**RE: Magothy Beach Lot 19 p/o Lot 20**

**Variance submittal**

353 South Drive  
Severna Park, MD. 21146  
Tax Map 24, Grid 21, Parcel 345  
**B.P.#B02434661**

## OFFICE OF PLANNING AND ZONING

DEVELOPED CONDITIONS OVERALL SITE PLAN  
VARIANCE PLAN  
**MAGOTHY BEACH ~ LOT 19 & P/O LOT 20**  
353 SOUTH DRIVE, SEVERNA PARK, MARYLAND 21146  
TAX ACCT. NO. 03-020-34391232  
TAX MAP 24 GRID 21 PARCEL 345 DISTRICT 3RD  
ANNE ARUNDEL COUNTY, MARYLAND

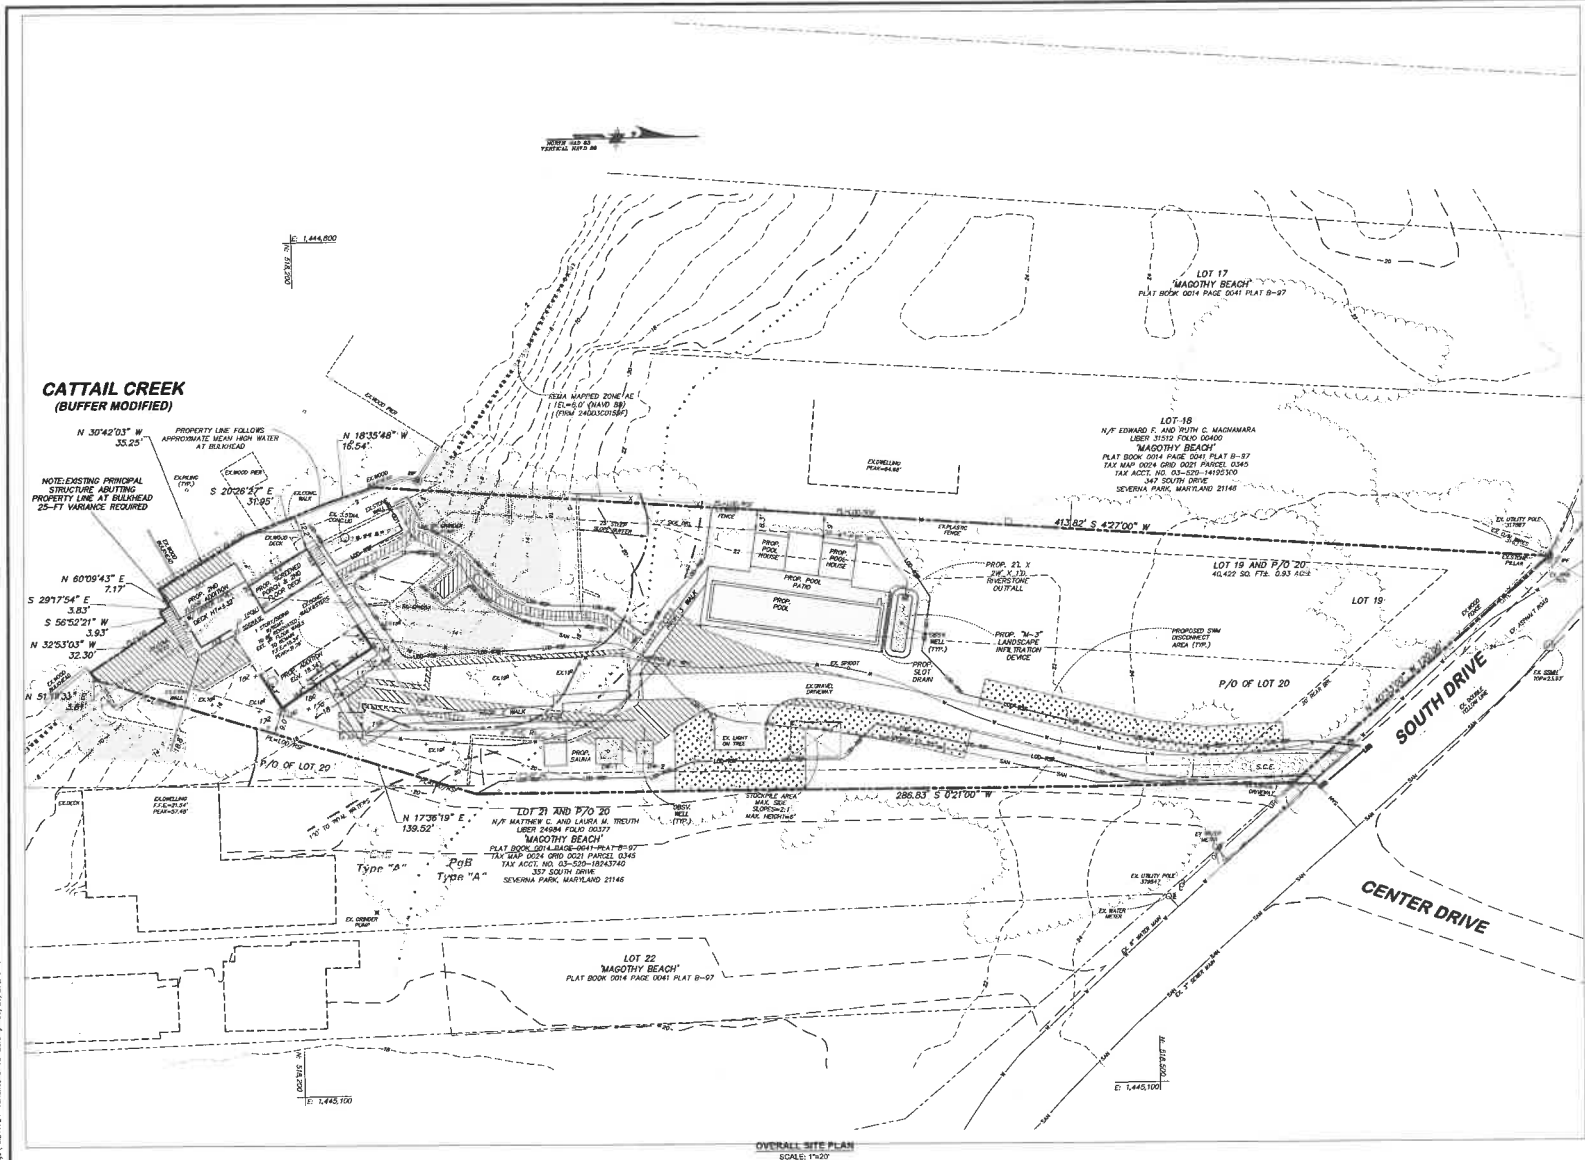
Although the clearing limitation is not part of the variance request, I will provide comment since it is mentioned in the Letter of Explanation. Clearing on this site is limited to 30% of the developed woodland. This clearing is limited to the minimum necessary to accommodate a house, septic system, driveway and reasonable amount of yard or parking. Based on the site plan, there is minimal clearing for the house and driveway and the majority of the clearing is for the pool and other recreational improvements. The proposed layout would not meet the test for approval to exceed the 30% clearing amount and must be reduced/redesigned. This requirement will be addressed with the permit application.

**Zoning Administration Section:** The site plan should add dimensions from the proposed improvement within the front setback to the front property line to allow for the variances to be calculated. The applicant should clarify what is meant by "dwelling to be renovated" as it is unclear if the dwelling is being rebuilt or if the proposal is just for additions. The letter of explanation provides little to no justification on why these improvements are required, how they represent the minimum necessary or why the applicant doesn't have reasonable use of a residential lot with the current improvements. Architectural drawings would be helpful to determine all of the proposed changes to the dwelling relative to the existing conditions.
